## ARCHITECTURAL REVIEW BOARD WORK SESSION AGENDA

**Agenda Item:** Discussion - 575 Herndon Parkway Development Plan

This item constitutes a continuation of the formal ARB assessment of the architectural components of an active rezoning application. HTOC Development Plan #24-01 proposes to change the property zoning at 575 Herndon Parkway to allow for redevelopment with a stick-over podium mixed use building. The building would have multi-family residential, retail, and office uses. The existing improvements on the property would be demolished. As part of the review process of this application, the ARB is tasked with providing a preliminary analysis of the architecture and reporting that analysis in a memo to the Planning Commission. The project would return to the ARB as an official case following the approval of the rezoning application and the site plan for the project. The ARB reviewed the conceptual design of this project at its October 2024 work session and provided substantial feedback. The applicant has provided an exhibit with revised architectural renderings and a narrative explaining the approach to the revisions. The staff memo from the earlier review has been provide

# PROPOSED BUILDING ELEVATIONS

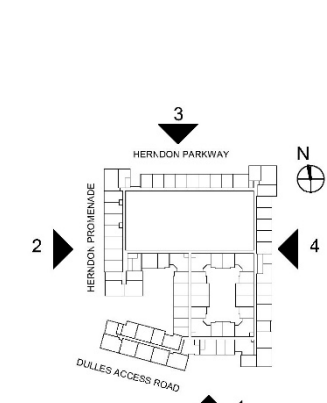
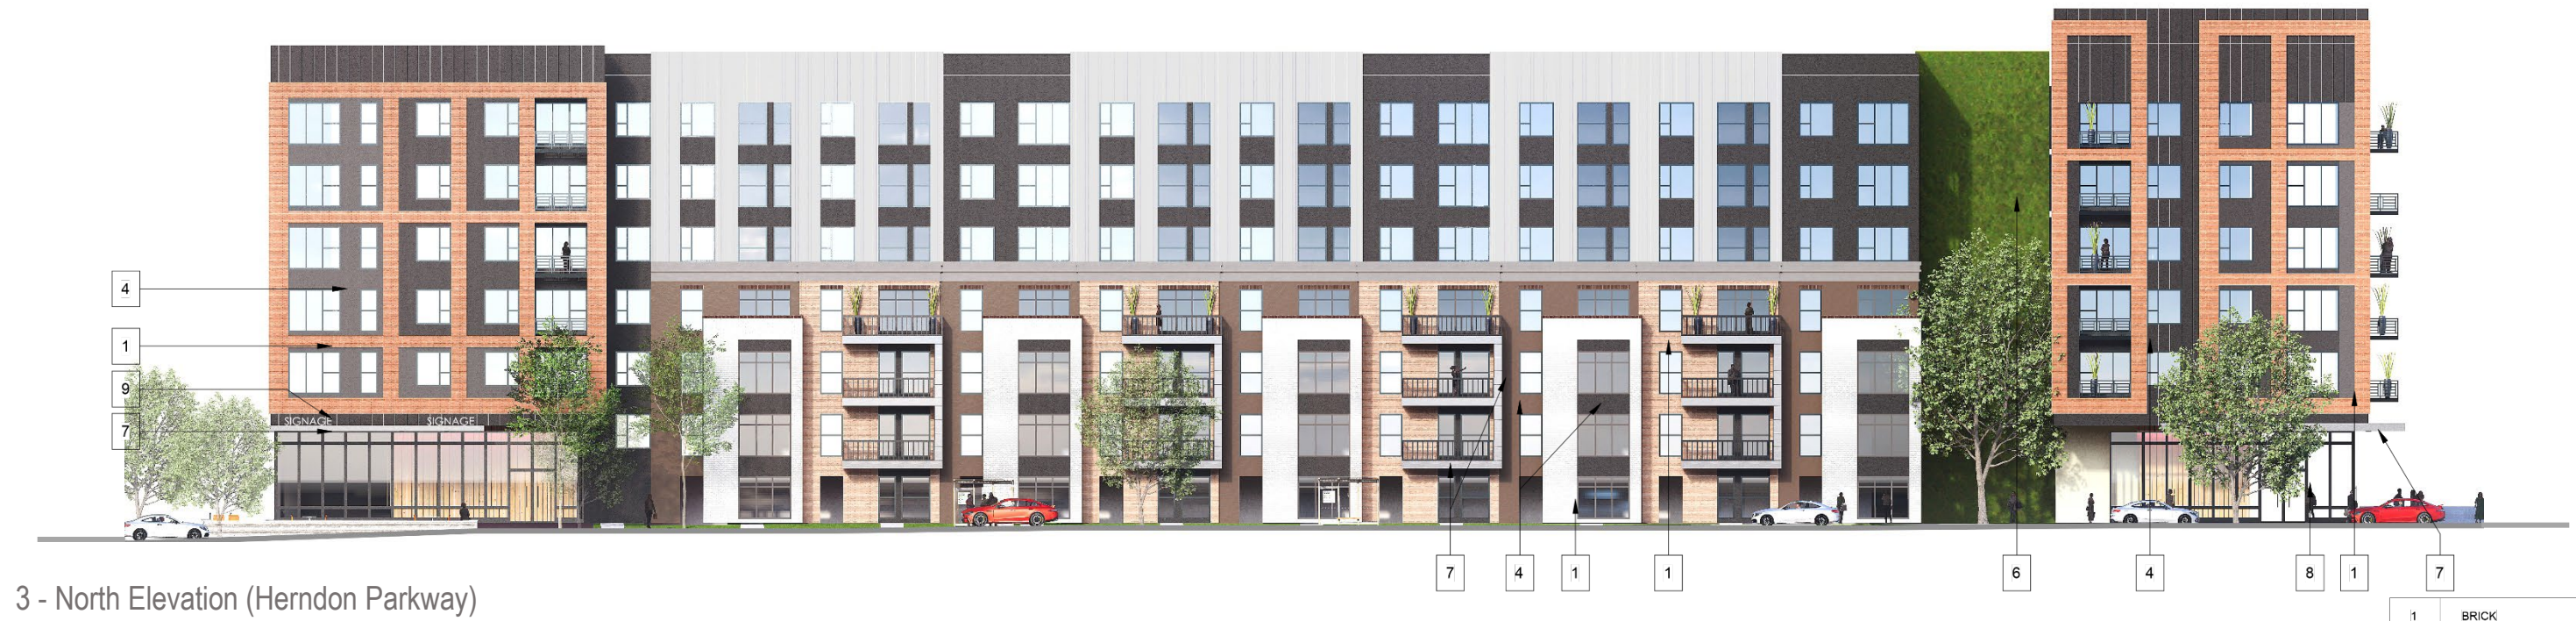
- Fibercement paneling remains relied upon as a primary cladding material. The light-colored building at the SW corner is entirely composed of this material. While a reduction in this reliance is recommended, where it is used, it should be managed to

ensure appropriate scale and articulation is achieved. Paneling can create larger forms and flatter surfaces, both of which can become problematic in the overall design. The size of the panels, the arrangement of the panels, the presence and dimensions of reveals within the panels, and the finish of the panels are all detailed variables that should be closely reviewed by the board. Specific to the building at the SW corner as an example, it's unclear how the horizontal joints for the full height vertical siding would be handled and whether the vertical reveals are strictly joint lines or articulated protrusions from the face of the wall. Also, the darker paneling seems to have a textured surface, which may be a good way to differentiate between paneling. However, if the intent is to strictly have smooth painted paneling, the building would not have the texture, scale, and design quality expected for the HTOC.

- The garage doors on the east elevation should be designed to fit well within the architecture of the building and have decorative characteristics. They should be standard roll-up doors.

- The design shows a few wall mural/TDB that are rendered as vegetated walls. These areas are important architectural hyphens and may have impacts on the success of the design across the entire elevation. The intended conceptual design for these areas should be provided to the board for its preliminary review.

- The storefronts are designed with full-height glass storefront systems. While this is a departure from more traditional storefront designs, it presents a good opportunity to have a strong visual connection between the interior and exterior spaces. For that to be successful, however, the glass must be transparent. Staff would not support this approach with reflective glazing.

- The middle composition of the north elevation requires further attention. This is the project's most public facing elevation with frontage along Herndon Parkway. Staff continues to support the design approach of having walk-outs units and facade treatments on the first four floors meant to mimic townhouses, however, the effectiveness of that technique was reduced without a step back for the upper three levels. A heavier and more articulated cornice separating the lower levels from the top levels may help to alleviate this concern. Consideration should also be given to redesigning the exterior treatments at the upper levels to create a completely distinct and subtle composition that is visually subservient to the "townhouses" on the lower levels but also clearly different in form and scale. The alternating narrow dark bays and wider white bays relate to neither the townhouses below nor the forms of the compositions elsewhere on the building. Staff is also concerned with the sole use of fibercement paneling for the upper level, which as earlier stated can present an overly flat and stark appearance.
